SERVICE BULLETIN

APPLICABILITY: 2017-23MY Impreza
2018-23MY Crosstrek
2019-24MY Forester
2022-24MY WRX
2019-24MY Ascent

NUMBER: 11-205-25

SUBJECT: DTC P1449 EVAP System Clog Detected / Repair Procedure

DRAIN FILTER / DESCRIPTION OF DESIGN CHANGE:

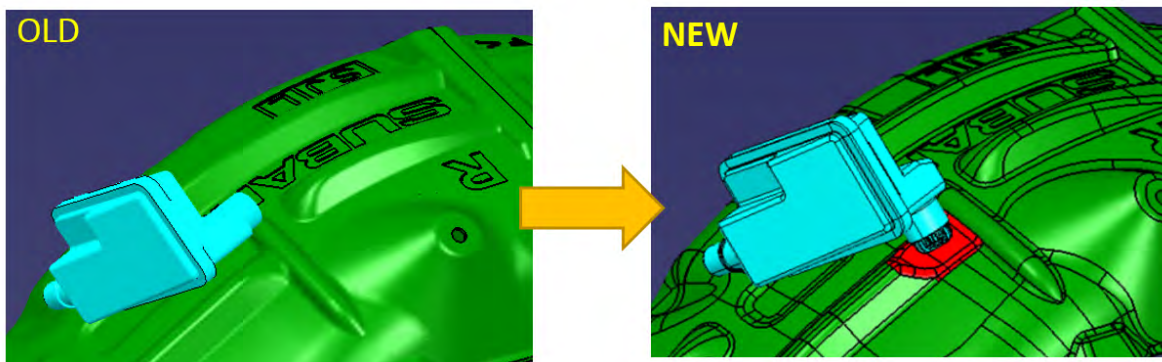
This bulletin announces the repair procedures to be followed when DTC P1449 (EVAP System Clog Detected) is detected by the Engine Control Module (ECM). New drain filter assemblies have been developed with an added protector to prevent debris build up. For some models, reprogramming and an additional mud guard will require replacement along with the drain filter. If DTC P1449 is found to be detected by the ECM, follow the service procedure outlined in this bulletin.

MUD GUARD / DESCRIPTION OF DESIGN CHANGE:

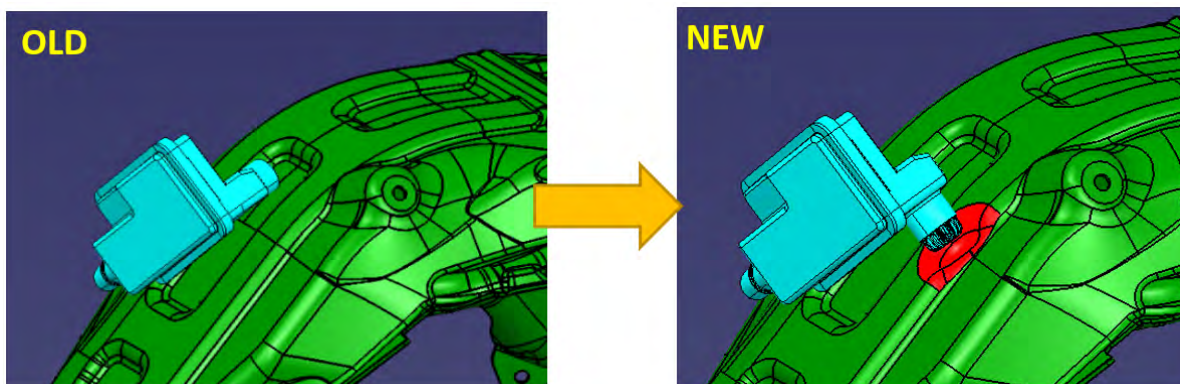
IMPORTANT: Mud guard replacement is **ONLY** required on Forester and WRX models.
